Comment Letter 35 – Friends of Riverside Hills

Re: DEIR for Sycamore Canyon Business Park Buildings 1 and 2

Response to Comment Letter 35 – Friends of Riverside Hills

Truck Trip Rate Comparison

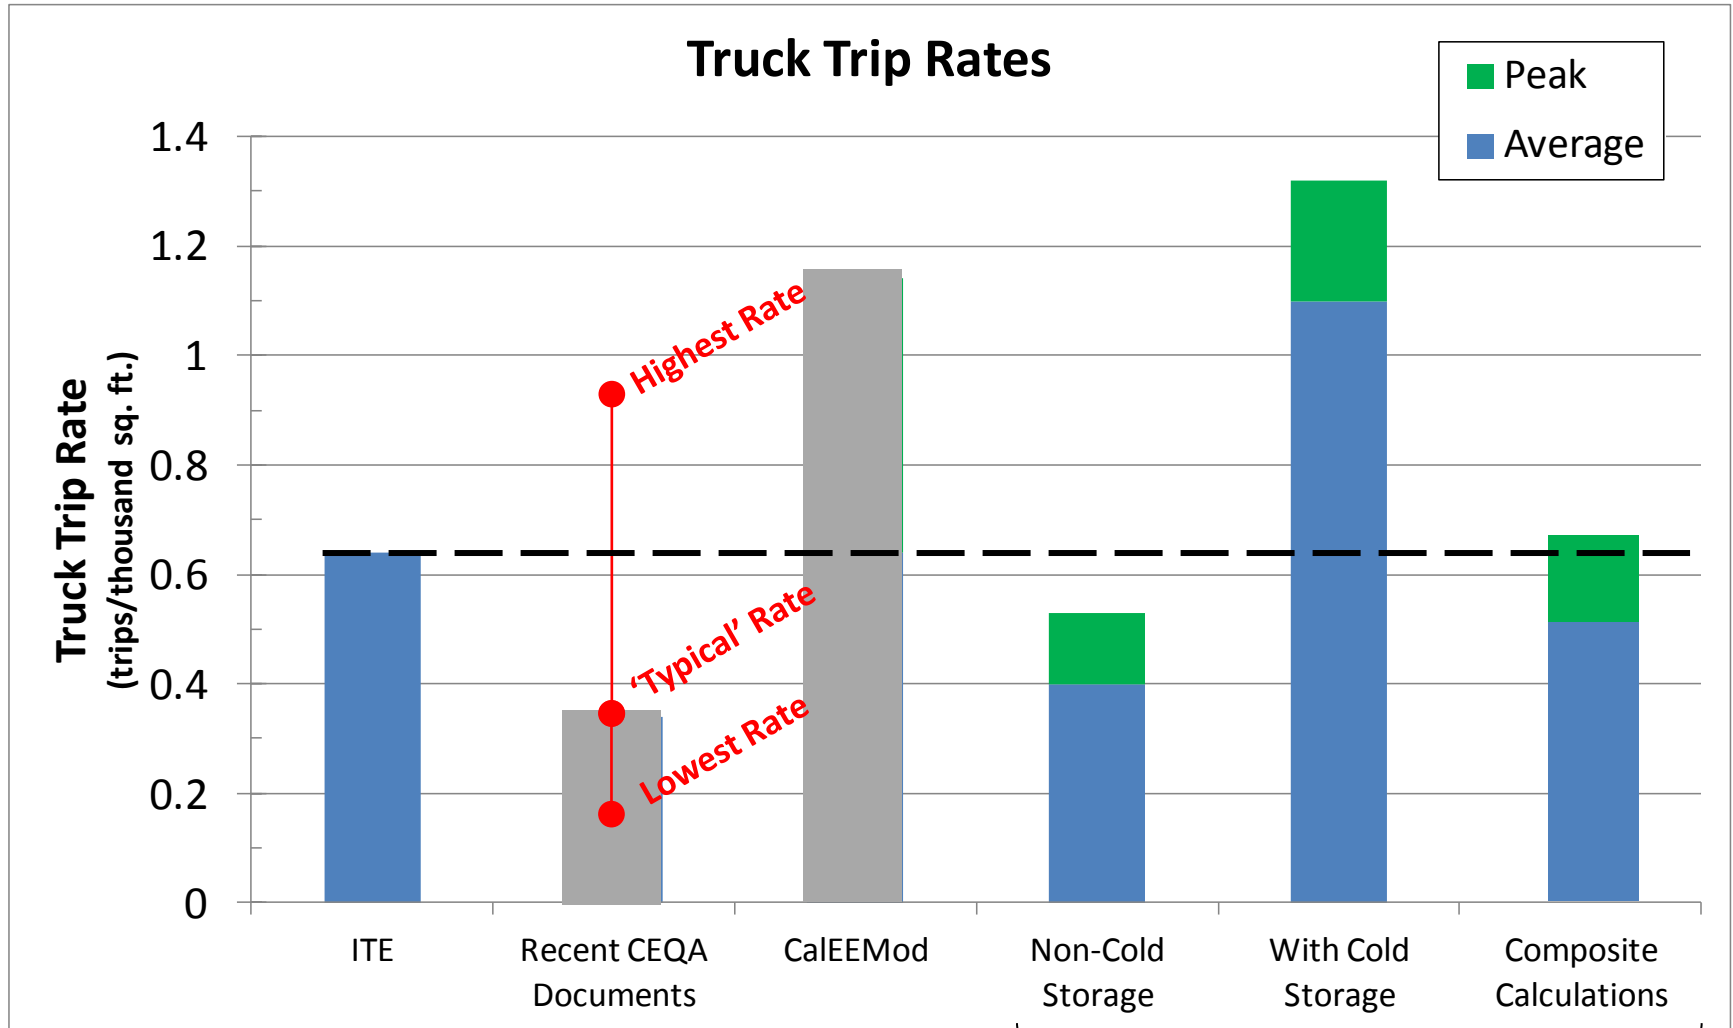
Business Position/ Recommendation

- Use current edition ITE truck trip rate as default
 - ITE higher than SCAQMD non-cold storage truck rate w/peak: 0.64 vs 0.53 trips/tsf
 - ITE similar to SCAQMD composite truck rate w/peak: 0.64 vs 0.66 trips/tsf
 - ITE captures “peak” daily
 - ITE has established procedures to update trip rates
 - Lead agencies can use site specific data

Staff Response

Staff Recommendations

- Implement staff interim recommendation
 - Use ITE default values until Governing Board action
 - Reflected in monthly IGR Board letter, NOP comment letter, and CalEEMod users noticed
- Option 1:
 - Continue staff interim recommendation
 - Supplement study by collecting more information on cold storage and peaking rates
- Option 2: See flow chart
